<b>ADDENDUM NO. :</b>	<b>Four (4)</b>
<b>BID DUE TIME AND DATE:</b>	2:00 p.m., April 30, 2019 <b>(No Change)</b>
<b>BIDDER QUESTIONS BY:</b>	11:59 a.m., April 23, 2019
<b>LAST ADDENDUM ISSUED:</b>	11:59 p.m., April 25, 2019

**THE PURPOSE FOR THIS ADDENDUM IS:**

- **To provide a response to questions raised by Plan Holders;**
- **To modify/clarify specifications and drawings.**

**A1 WALL SECTION**  
SCALE: 1/2" = 1'-0"

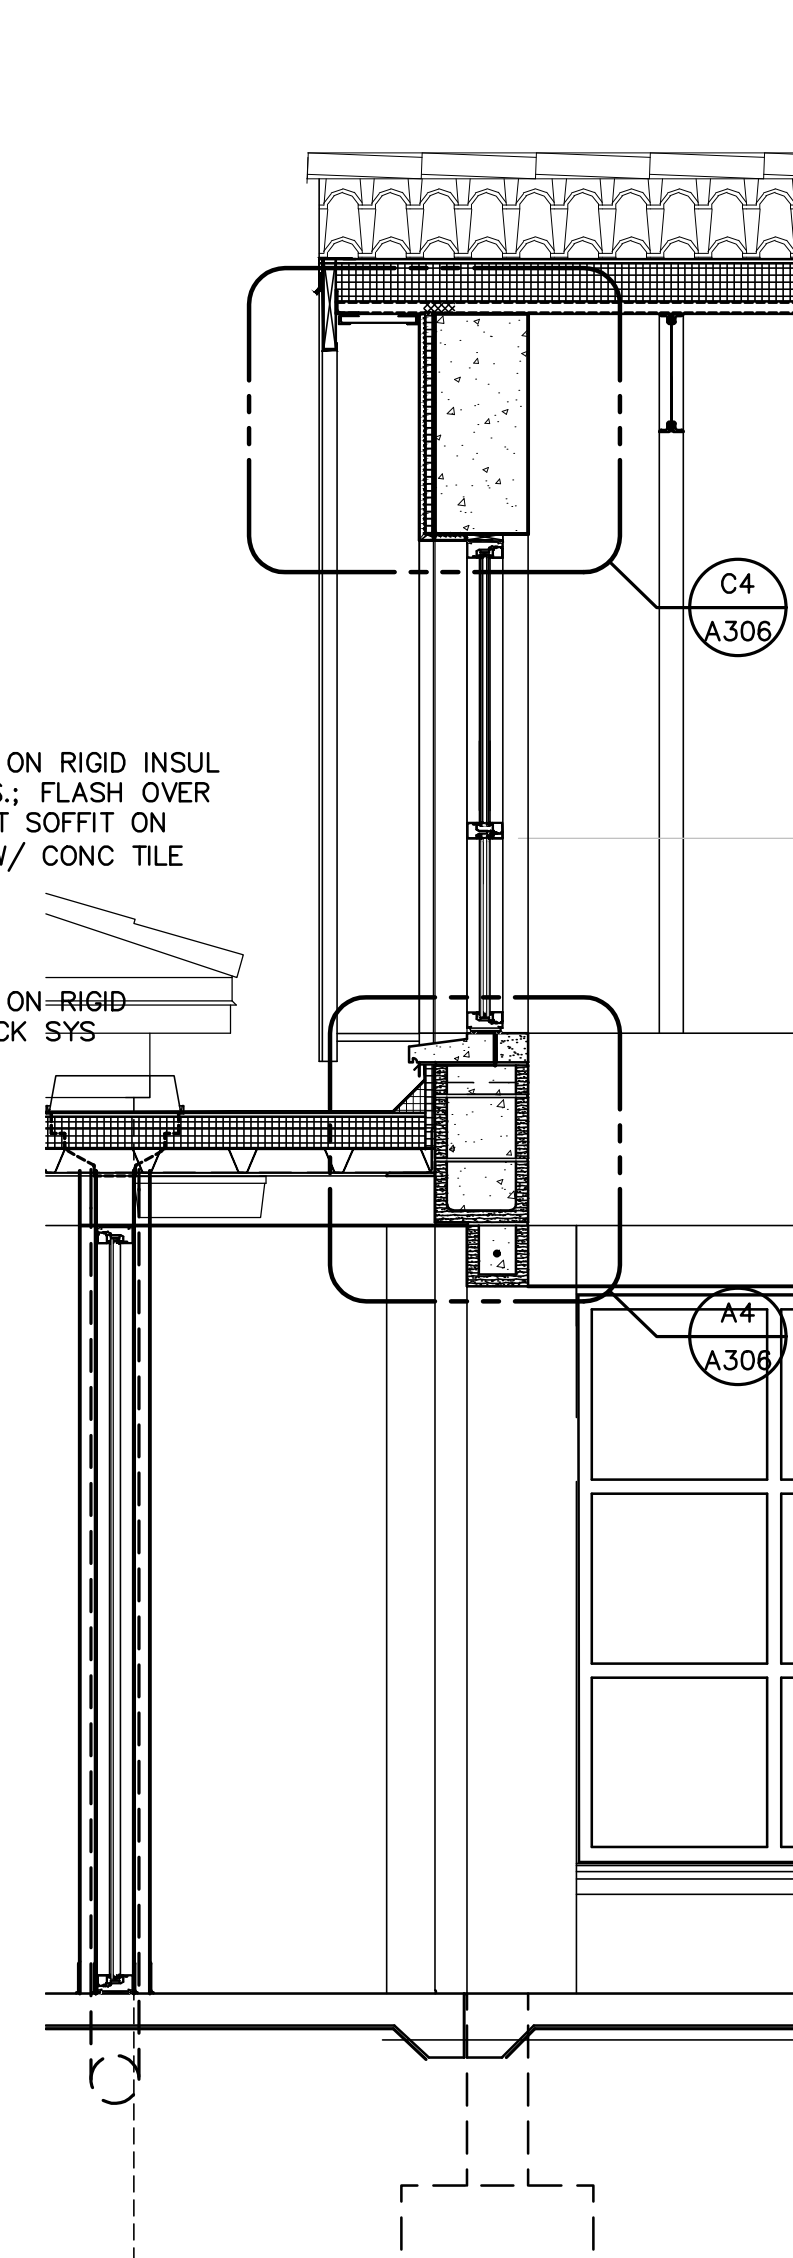
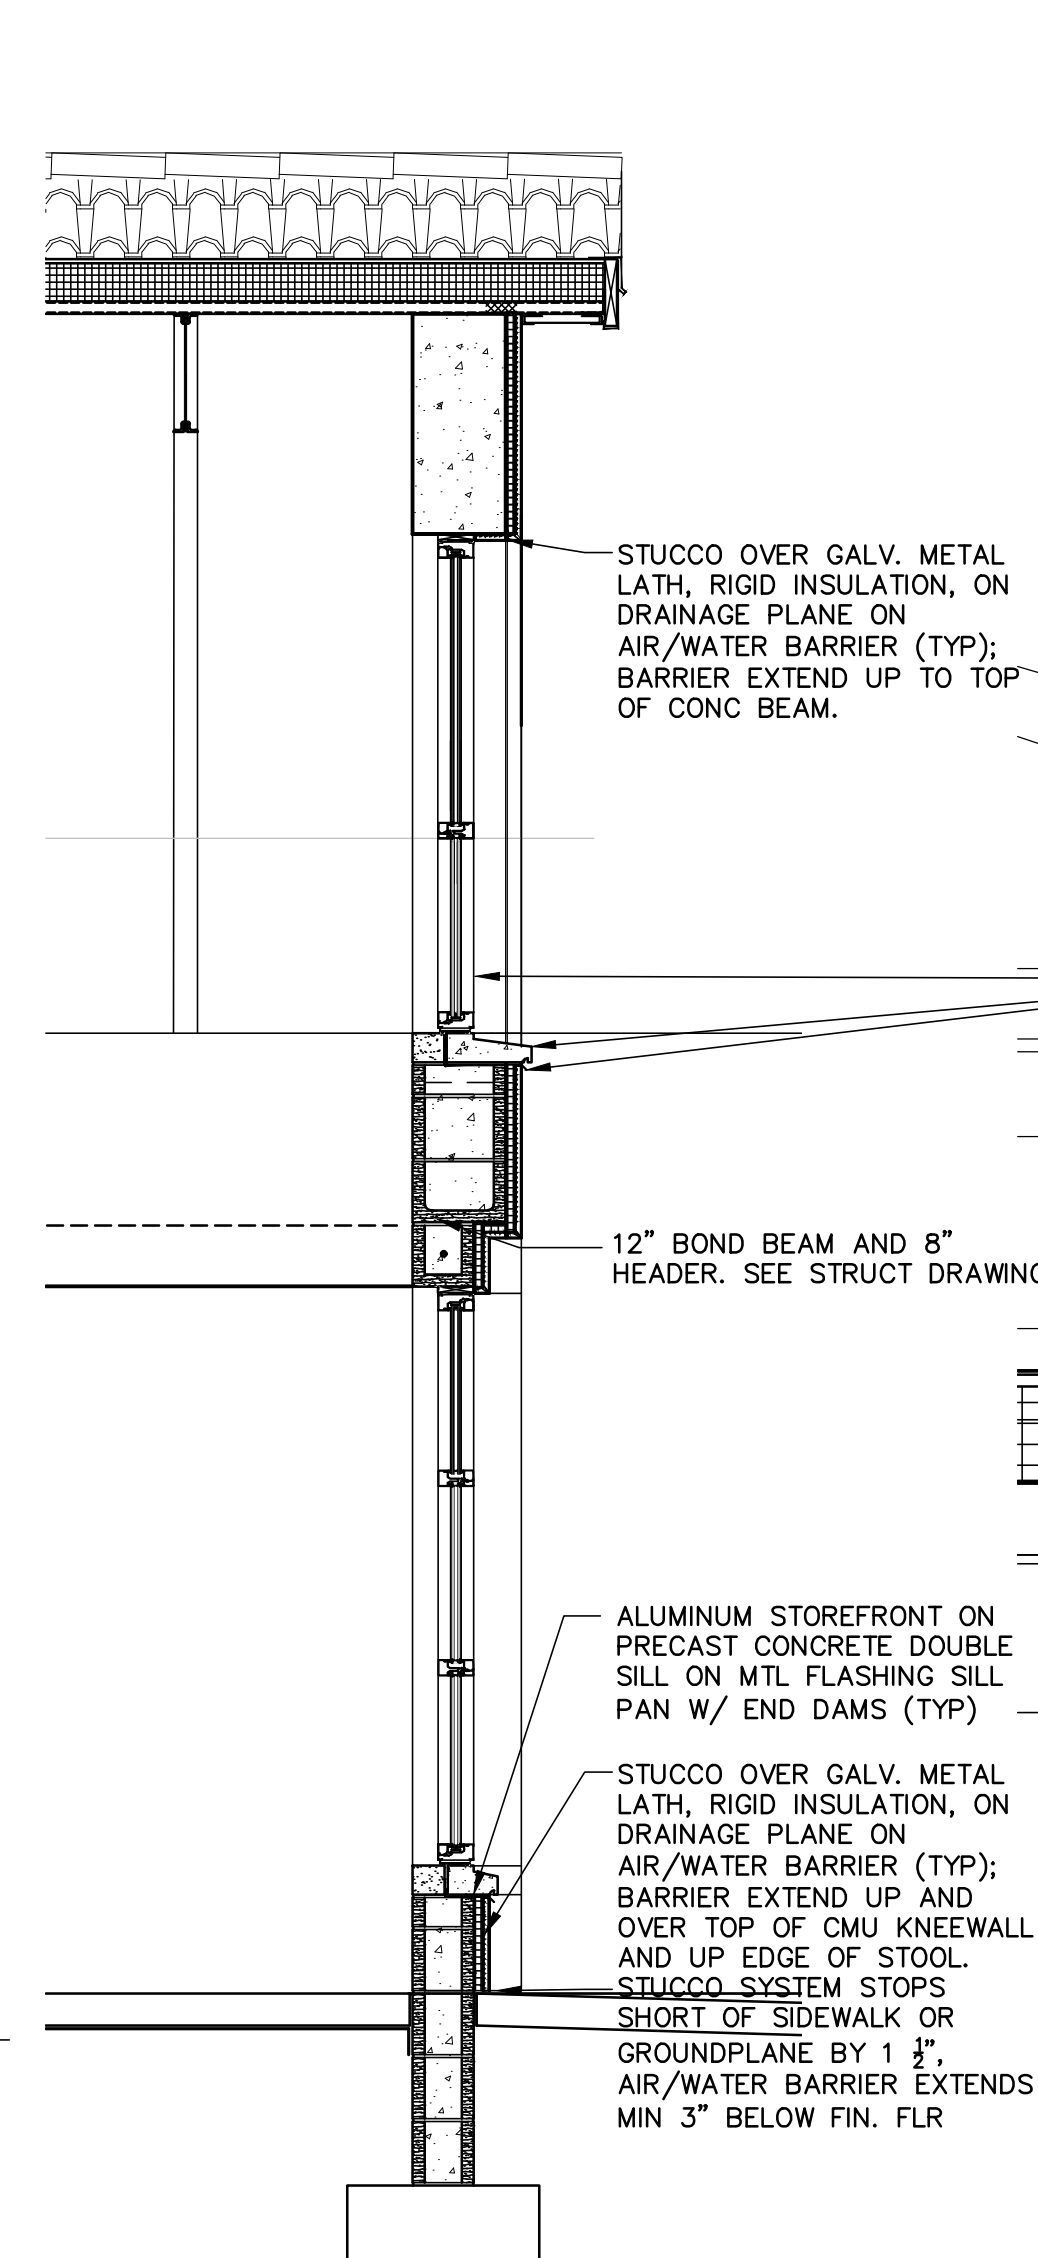
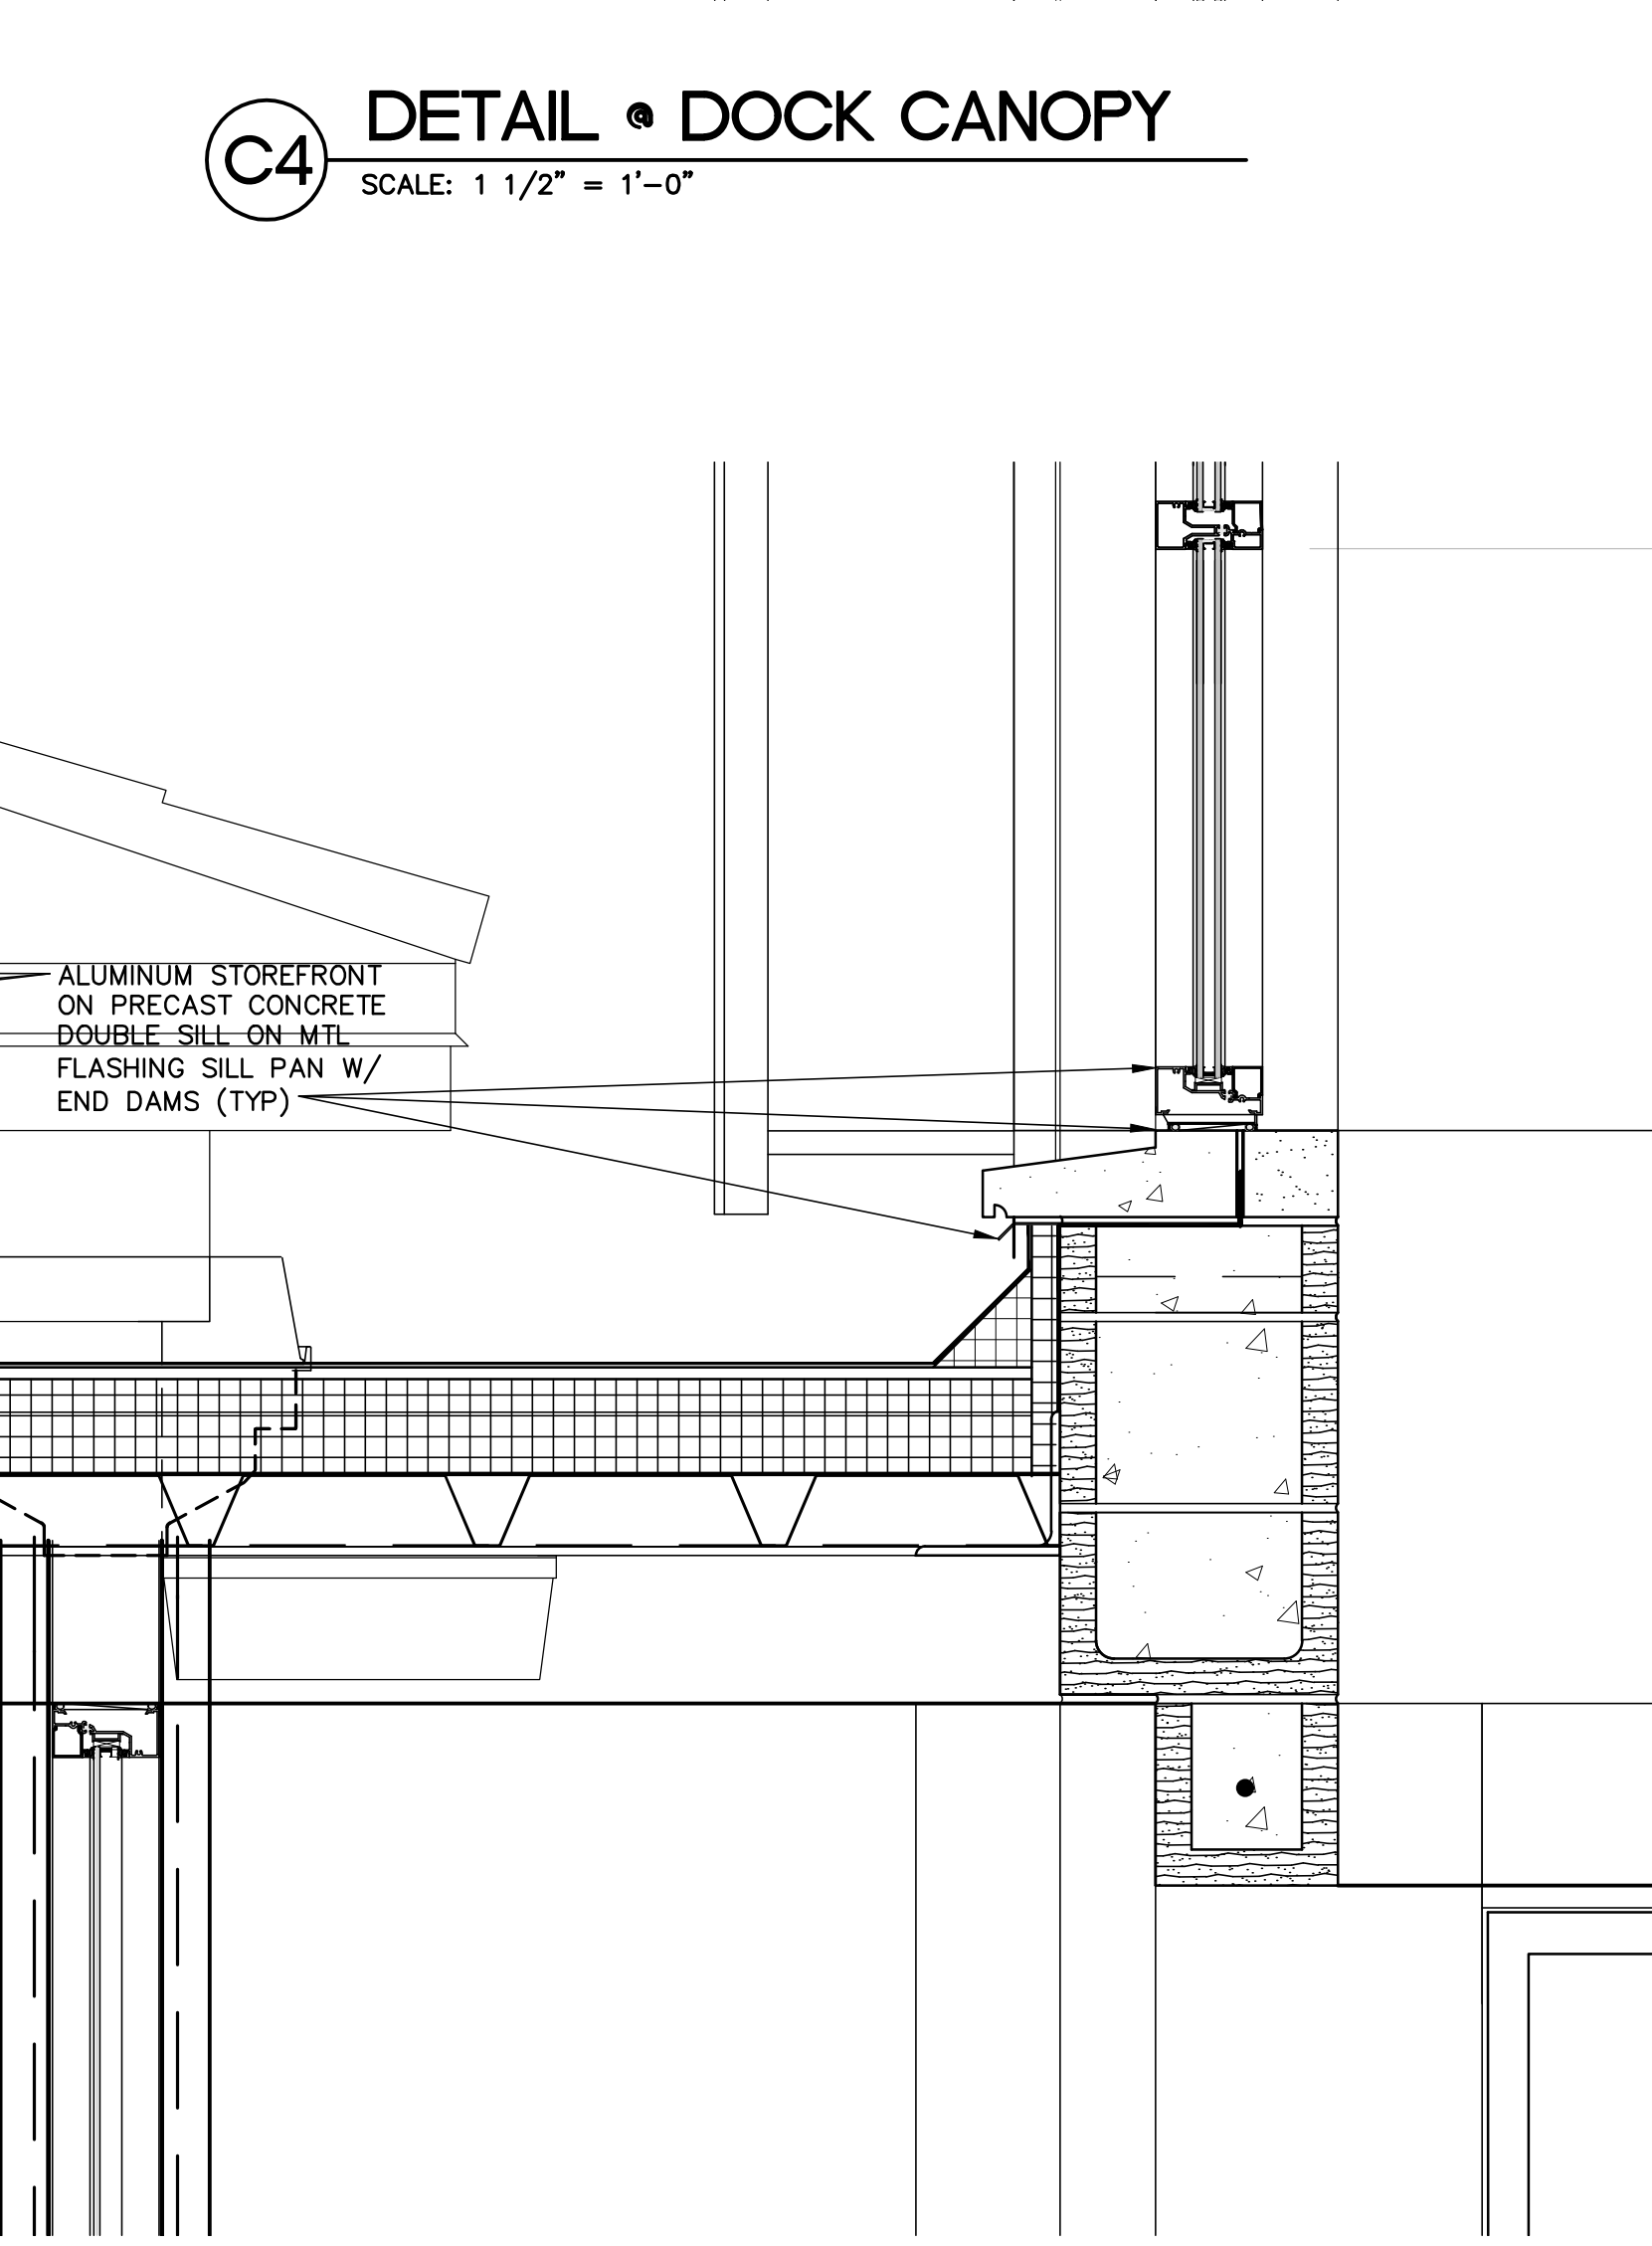
- Clarification on the wall types (section on acoustical separation, 2 hr, and detail at top of 10' wall) and ceiling cloud detail(s) and finish details such intent of columns for exposed electrical on CMU
- HVAC details such as air handler coil connection (what's needed re isolation valves, strainers, etc.)
- Extent of chilled water line treatment
- Specs/detail on OA louver to be installed within storefront (shown on HVAC, visible on Section A301, not A202 or A602)
- Redundancy on, and revisions to a few Hardware items; see hardware Spec sections attached.
- Sections clarified to indicate sill pan, as well as location of drainage barrier; all sections at stucco clarified to show weep at base of drainage plane. Additionally, simplify cast sills.

- A301 Building Sections
- A302 Building Sections
- A303 Ext Wall Sections & Details
- A304 Ext Wall Sections & Details
- A306 Ext Wall Sections & Details
- A502 Ceiling Details
- A601 Finish Schedule w/ Details
- P101, Updated plan to show missing fixtures and missing sanitary and vent piping
- P102, Updated plan to show missing fixtures, missing domestic water piping and missing gas piping
- P101, Updated plan to show missing fixtures and missing sanitary and vent piping
- P201, Updated plan to show missing fixtures and missing sanitary and vent piping
- P202, Updated plan to show missing fixtures, domestic water piping and missing gas piping
- M401, Added detail for chilled water connections to AHU
